Engineering Change Notification

This notice is to inform you of a change to the following products:

- NHD-0216SZW-BB5**
- NHD-0216SZW-BG5**
- NHD-0216SZW-BY5**
- NHD-0216SZW-BB5-TS**
- NHD-0216SZW-BG5-SCS**

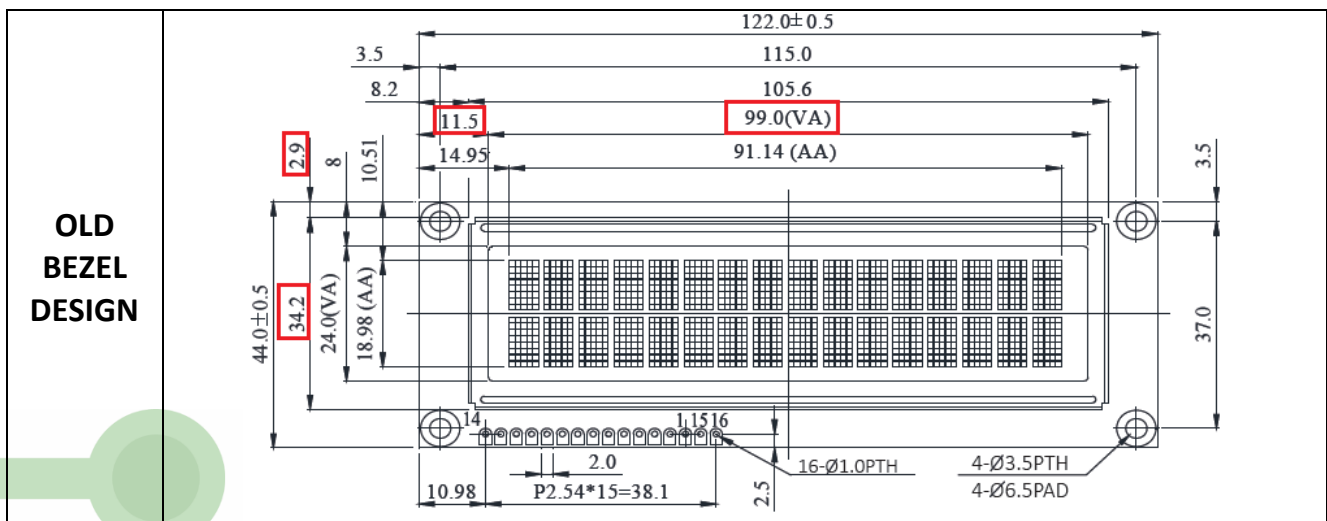
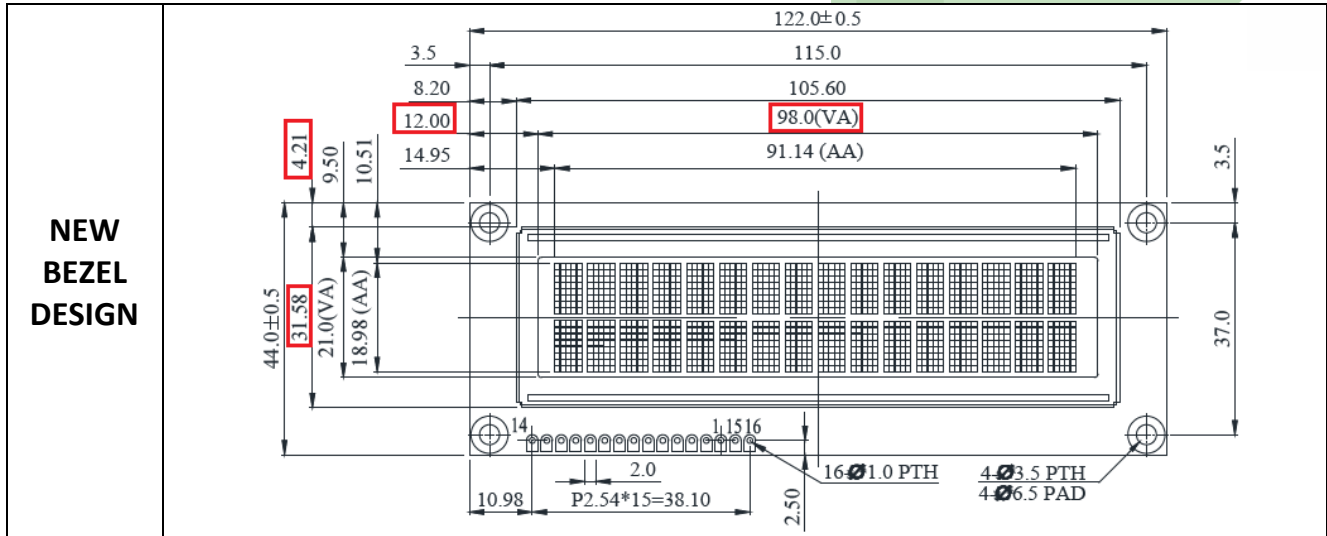
The OLED Panel size has been modified in the models listed above. This change was made for quality improvements to the manufacturing process. The change required a bezel redesign which better secures the OLED panel. The dimensions highlighted below have been modified.

Overall Bezel Height has been reduced from 34.2mm to 31.58mm.
 Horizontal Viewing Area has been reduced from 99.0mm to 98.0mm.
 Active Area (visible character area) has remained unchanged.
